MIL ON With DTC(s) P1C5F19 and/or P1C5D19 Causing Over-current Condition

Service Category Vehicle Interior

Section Meter/Gauge/Display

Figure 1. View of Terminals at the Inverter

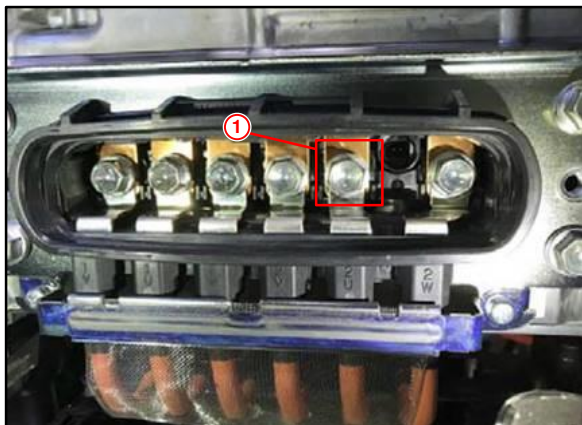
These conditions typically occur on low vehicle mileage (less than 5,000). After an occurrence, the vehicle will be able to run normally with no drivability issues. Follow the Repair Procedure in this bulletin to address these conditions.

1 Debris Created From Bolt Tightening

3. Using compressed air, blow out ALL potential debris on the terminals and connections area of the inverter and transaxle. Visually confirm there is no debris present on terminals and connections area.
4. Reinstall the MG cable with NEW bolts into the transaxle assembly. Inverter bolts can be reused. Refer to TIS, applicable model and model year Repair Manual:
 - [2019](#) / [2020](#) Avalon HV:
Drivetrain – Hybrid Transmission/Transaxle – “P710 (Hybrid Transmission / Transaxle): Motor Cable: Installation”
 - [2019](#) / [2020](#) Camry HV:
Drivetrain – Hybrid Transmission/Transaxle – “P710 (Hybrid Transmission / Transaxle): Motor Cable: Installation”
 - [2019](#) / [2020](#) RAV4 HV:
Drivetrain – Hybrid Transmission/Transaxle – “P710 (Hybrid Transmission / Transaxle): Motor Cable: Installation”

Ensure correct fastening tools and torque are used when installing the MG cable. Over tightening can create debris.
